STEREO CONFIGURATION CHANGE REQUEST

| STS Number: | Payload: STEREO | Name: Dave Curtis | <input checked="" type="checkbox"/> Routine <input type="checkbox"/> Urgent <input type="checkbox"/> Emergency | | | | | |
| Component : | Experiment: IMPACT | Organization: U.C. Berkeley | | | | | | |

**Example:
 X AXIS 0dB RANDOM
 R3X
 SWEA and STE-D X-axis
 Envelope: 9.50 g rms**

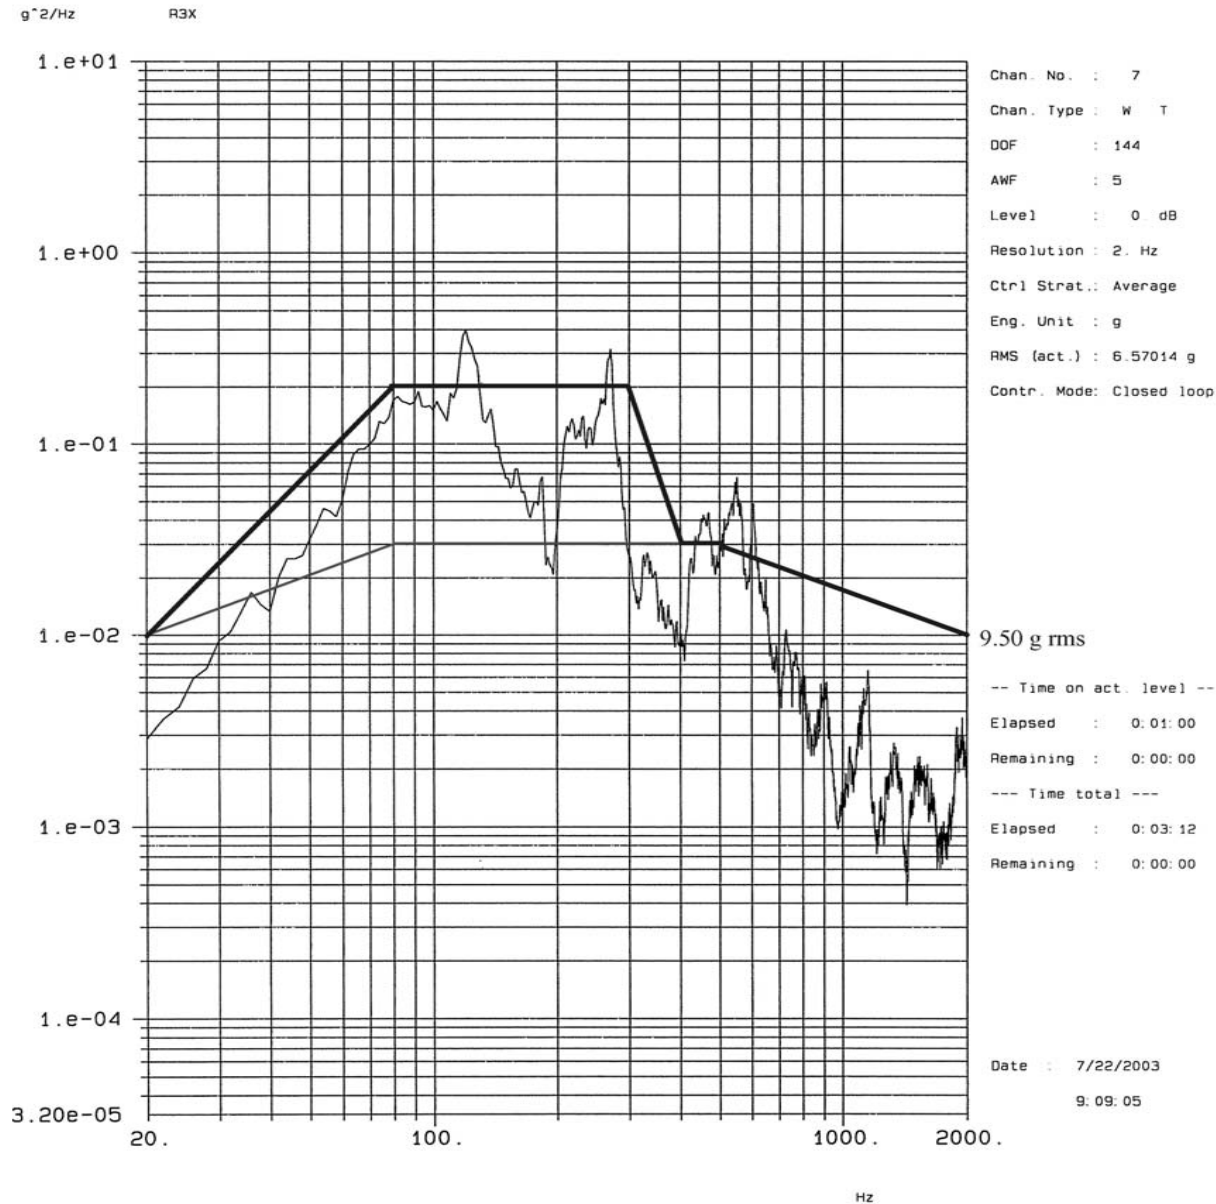
| <p>The STEREO Environmental Requirements Document (7381-9003 rev B) section 3.4.2.1 states that instruments mounted to booms shall be vibrated with the boom, with exception to be negotiated. There is an enhanced 14.7grms random vibration spectrum supplied for boom mounted instruments vibrated separately. Further the test matrix in appendix B of that document indicates the boom instruments are vibrated with the boom. We propose to vibrate SWEA separate from the boom at levels derived from the boom test (using a mass dummy in place of SWEA for the boom vibration tests).</p> | | | | | | | | |
| <p>We have vibrated the qualification boom with the instruments replaced by mass dummies with accelerometers. From this data we have constructed a vibration spectrum for SWEA using the FEMCI Book (see attached). We will verify this data from the flight boom vibration tests prior to SWEA vibration. SWEA will not be available until after the rest of the boom is ready to start vibration. Waiting for SWEA to be ready will disrupt our schedule, impacting suite delivery. Also there are logistical and risk issues with handling and shipping the boom with SWEA attached which would have to be addressed,</p> | | | | | | | | |

All instrument vibration envelopes will be verified by FM1 vibration prior to instrument vibration testing

- **Created from The FEMCI Book – Creating a Random Vibration Component Test Specification**
